Docket Number:	24-OPT-02
Project Title:	Compass Energy Storage Project
TN #:	259487
Document Title:	Michael McGrady Comments - Inaccurate Appendix - Parcel Map
Description:	Inaccurate Appendix B (a) (1) (E) - Parcel Map
Filer:	System
Organization:	Michael McGrady
Submitter Role:	Public
Submission Date:	10/8/2024 2:59:39 PM
Docketed Date:	10/8/2024

Inaccurate Appendix B (a) (1) (E) - Parcel Map

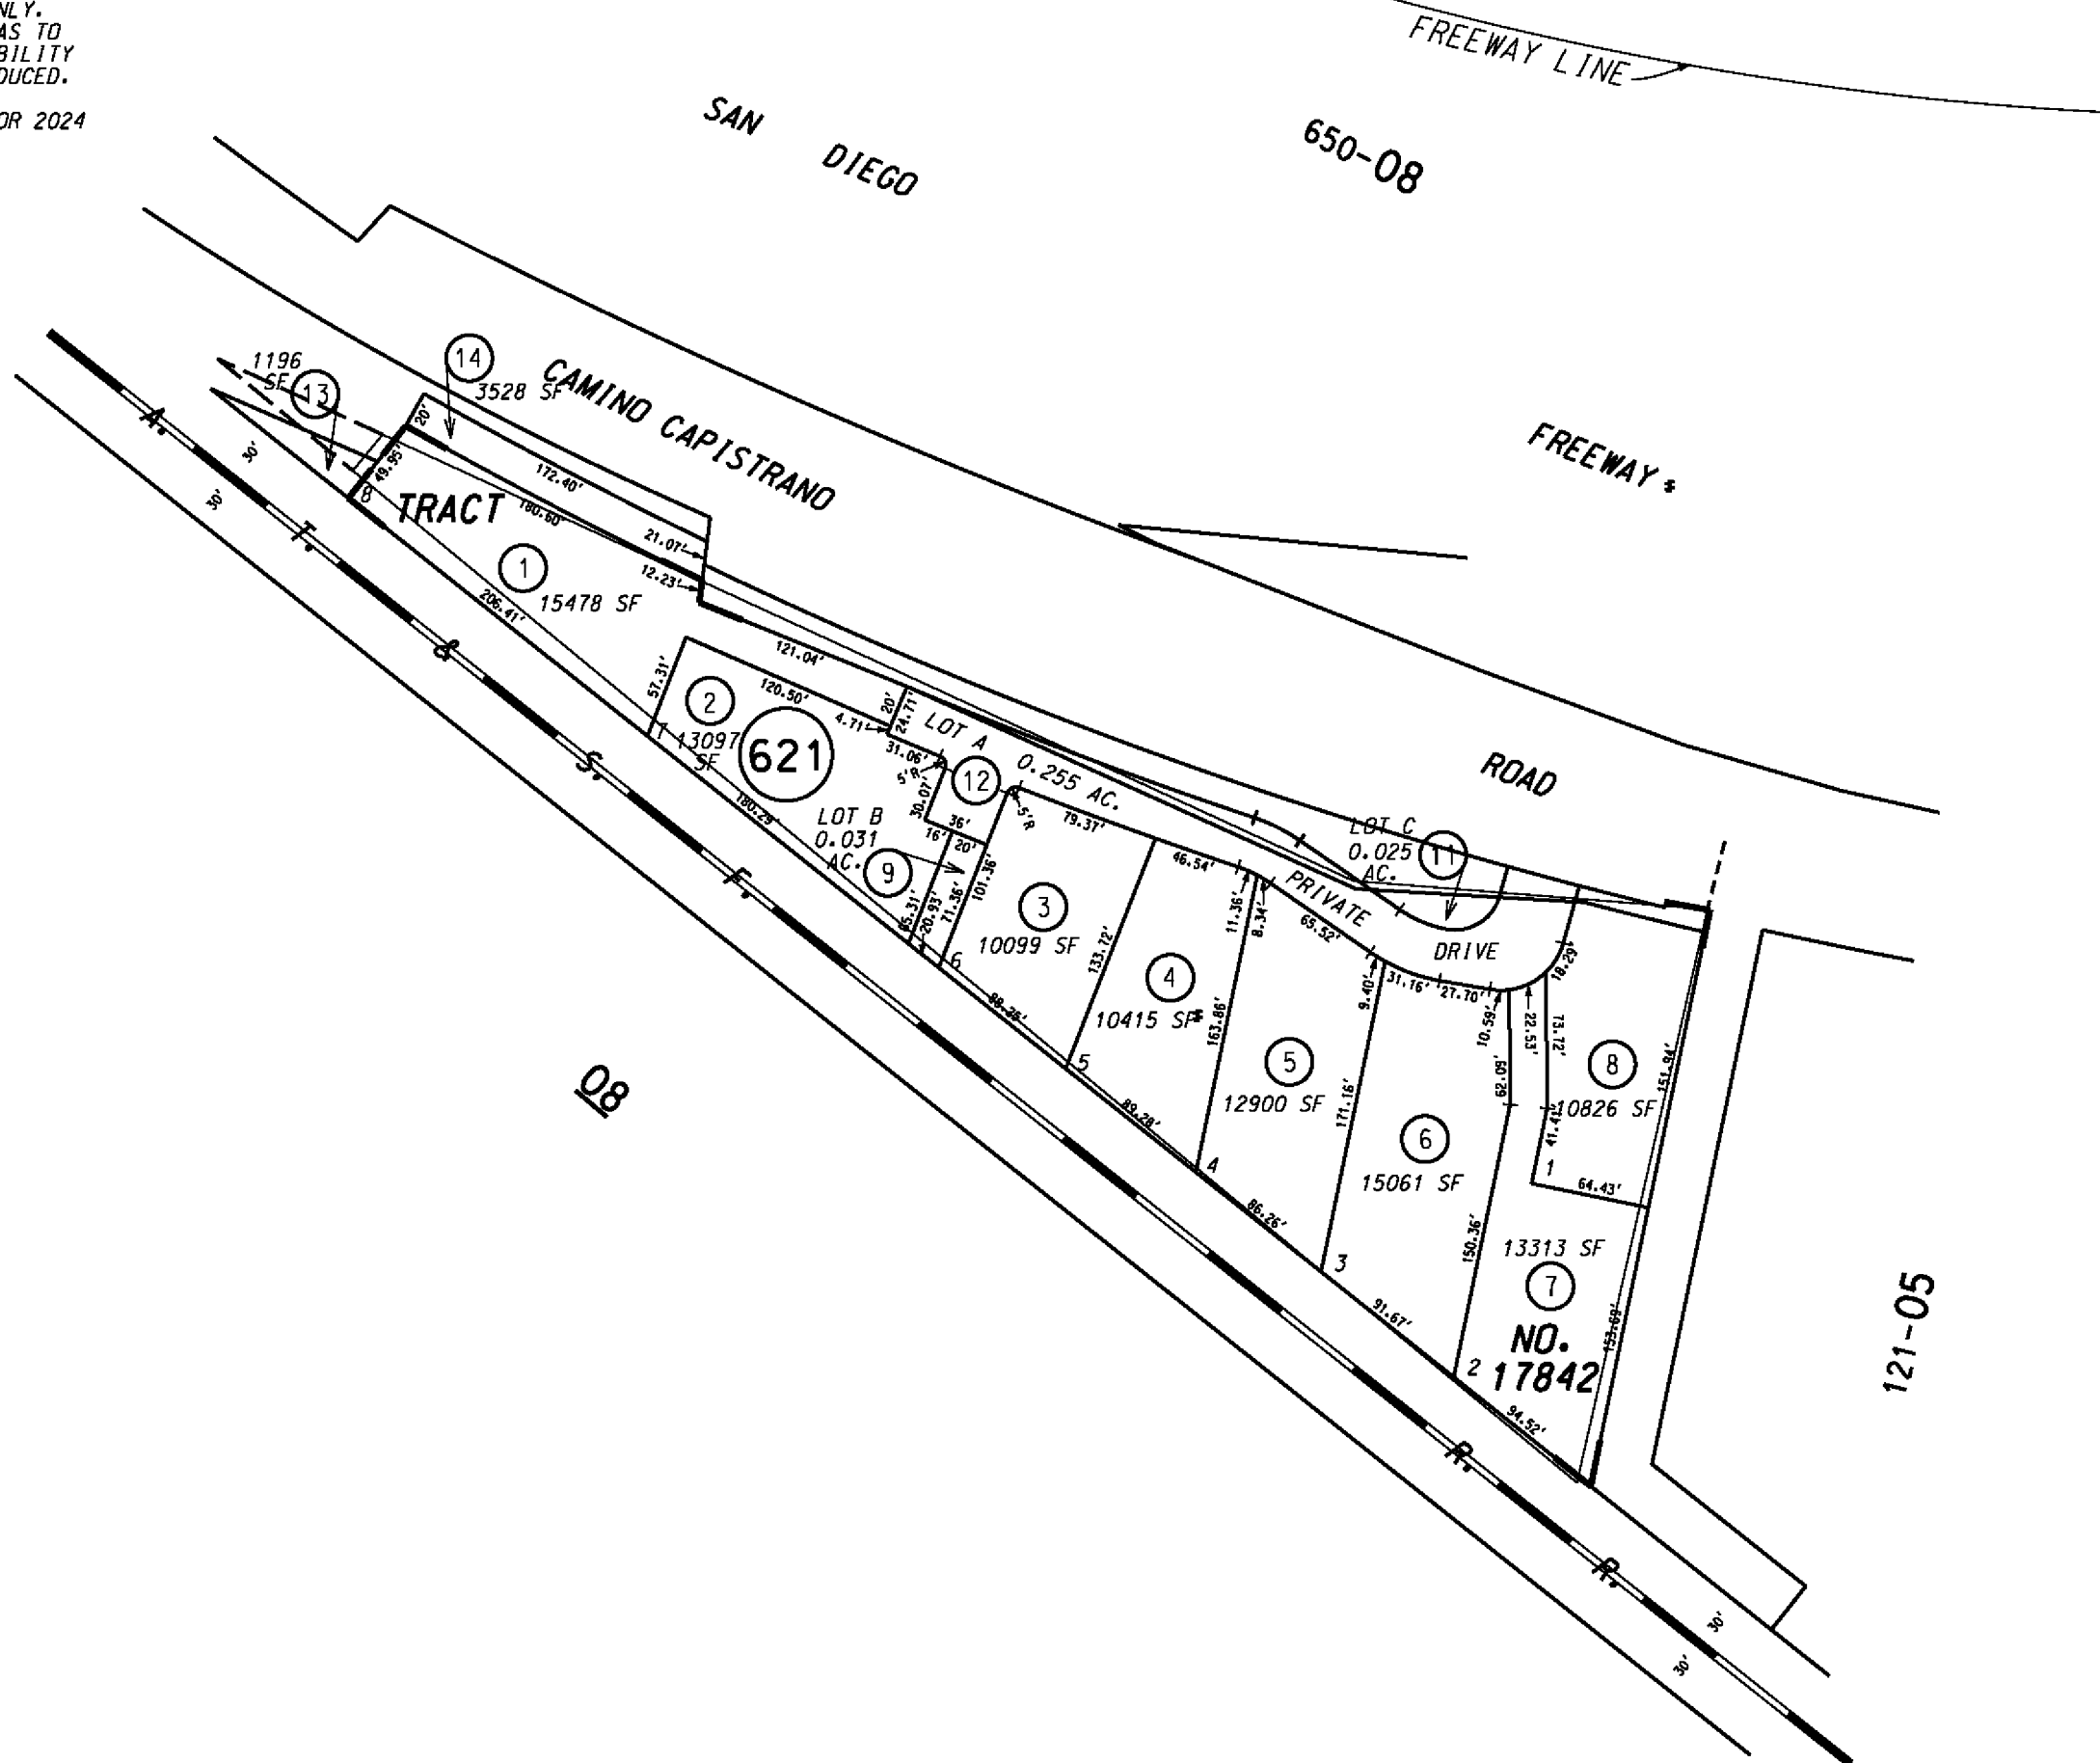
It is hoped that the subsequent filing of ATT8 DR ES-3 Updated Appendix 1B Confidential (TN 258674) is now accurate. The publicly accessible parcel map of the project and surrounding properties, submitted by Dudek, omits the eight homes/families living less than 1,000 feet downwind from the proposed Compass location.
